## Product Change Notice

Issue Date: 8 Sept 2014

Qualify new tool at the existing supplier for the lens of the below products.

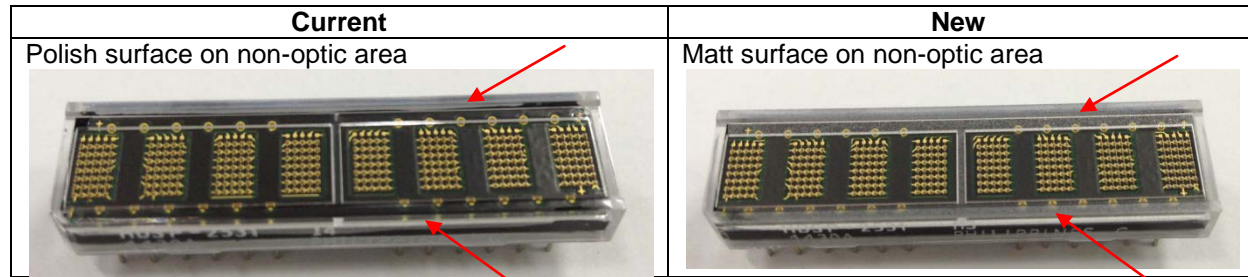
There is no change to the material and supplier. The characteristic and dimension of the product are the same except for the cosmetic appearance stated as below:
